Re: NH Site Evaluation Committee Antrim Wind, Docket No. 2015-02

All of my comments pertain to sound and the Applicants adherence to the new SEC criteria, specifically:

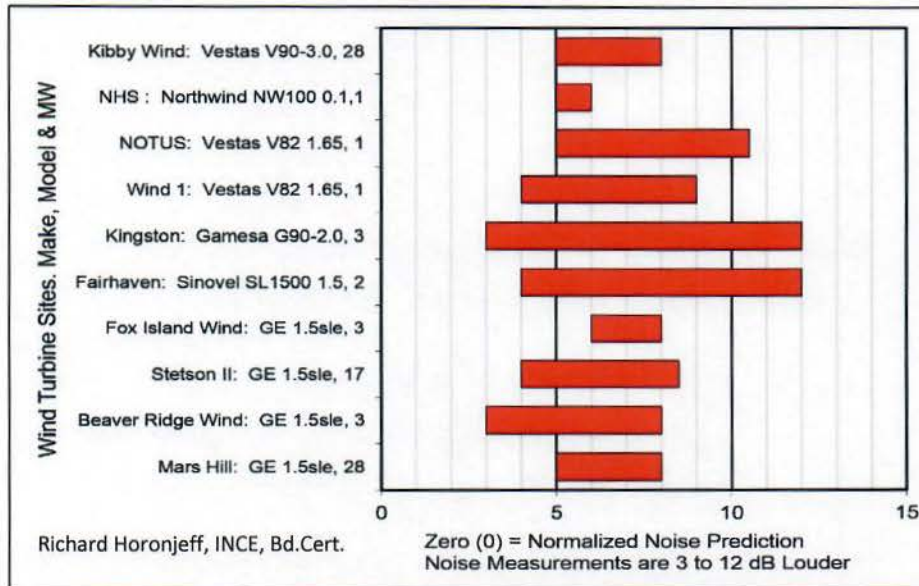
2. In the “SUPPLEMENTAL PREFILED DIRECT TESTIMONY OF ROBERT D. O’NEAL ON BEHALF OF ANTRIM WIND ENERGY, LLC page 3, line 15 Mr. O’Neal rebuts testimony of Richard James and Lisa Linowes with respect to applying a +/- 3 dBA adjustment to the estimated sounds levels specified in ISO 9613-2. Mr. O’Neal testifies “*The ISO 9613-2 standard states, for receivers at a distance between 100 meters (328 feet) and 1,000 meters (3,280 feet) from a source AND ranging from 0 to 30 meters (98 feet) high, the model results are estimated to be accurate to +/- 3 dBA. Hub heights of the wind turbines range from 79.5 m (261 feet) to 92.5 m (303 feet) which is well above the 98 foot limit in the accuracy clause. Therefore, this accuracy clause is not applicable. There is no +/- 3 dBA “correction.” The Sound Report correctly followed the ISO 9613-2 standard.*” (emphasis added) However in the Applicant’s Sound Level Assessment report, the Applicant asserts that Wind Turbine sound originates from two sources, mechanical and aerodynamic noise. Mechanical noise originates from the hub while aerodynamic noise originates from “the wind turbine blades with localized airflow inhomogeneities and wakes from other turbine blades and from airflow across the surface of the blades, particularly the front and trailing edges. Aerodynamic sound generally increases with increasing wind speed”. Therefore the entire blade should be considered as a noise generator and in particular the blade tips will

generate most of the sound since the tip of the blades are traveling at the fastest apparent wind speed. The Applicant erred in assuming that the hub of the turbine generated the sound and did not consider that the blade tips also generate aerodynamic sound. Therefore the sound source for turbines with a hub height of 79.5m minus the length of the blade (56.5 meters) = 23 meters this is well within the 30 meter range to requiring the +/- 3 dBA adjustment to the modeled sound levels as required by ISO 9613-2. Thus the +/-3 dBA adjustment applies.
